Access Compliance Report

Public Rights-of-Way

(Curb Ramps)

Intersection ID: 10040791	Main Street: W_W_T_HARRIS_BV	Cross Street: N/A	Location: NW
ADA ID: 9964571FFDF5	Ramp Type: Perp	Initial Pass/Fail: Fail	Overall Compliance: No
		Severity Score: 8.75	
Codes/Mitigation Info/Possible Solution		Field Measurements/Component Compliance

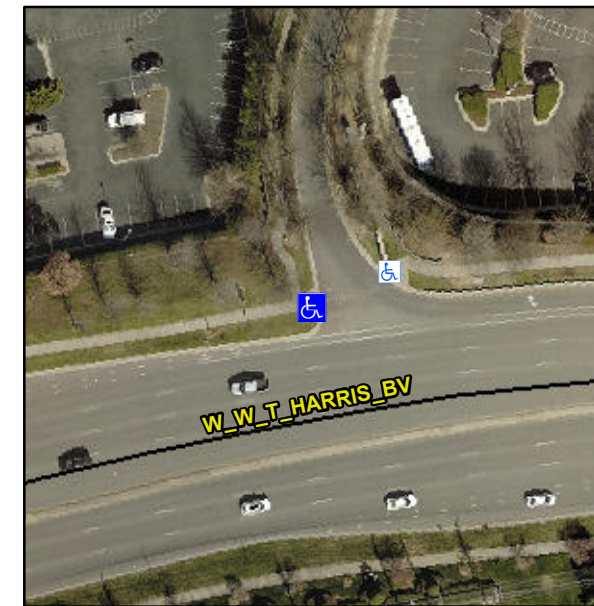
REPLACED PREVIOUS MARKER 1.0 IN LIP

Not Found, R304.5.1

Compliance	Description	Data	Compliance	Description	Data
N/A	Ramp Length (in)	83.0	Yes	Ramp Slope (%)	7.0
No	Ramp Width (in)	46.5	Yes	Ramp XSlope (%)	1.3
N/A	Flare Type LT	N/A	N/A	Flare Type RT	N/A
N/A	Flare Slope LT (%)	N/A	N/A	Flare Slope RT (%)	N/A
N/A	Flare Traversable LT?	N/A	N/A	Flare Traversable RT?	N/A
N/A	Landing Length (in)	N/A	N/A	DWS Provided?	N/A
N/A	Landing Width (in)	N/A	N/A	DWS Contrast?	N/A
N/A	Landing Slope (%)	N/A	N/A	DWS Length (in)	N/A
N/A	Landing X Slope (%)	N/A	N/A	DWS Full Width?	N/A
N/A	Landing Curb? (Y/N)	N/A	N/A	DWS Offset (in)	N/A
N/A	Shared Landing?	N/A			
N/A	Gutter Ponding?	N/A	N/A	Gutter Slope (%)	N/A
N/A	Gutter Lip Ht (in)	N/A	N/A	Gutter X Slope (%)	N/A
N/A	Painted X Walk1?	No	N/A	Painted X Walk2?	N/A
	X Walk 1 Direction	To E		X Walk 2 Direction	N/A
N/A	X Walk 1 Width (in)	N/A	N/A	X Walk 2 Width (in)	N/A
	X Walk 1 Slope (%)	2.2		X Walk 2 Slope (%)	N/A
	X Walk 1 X Slope (%)	2.4		X Walk 2 X Slope (%)	N/A

Remove & Replace Entire Ramp.
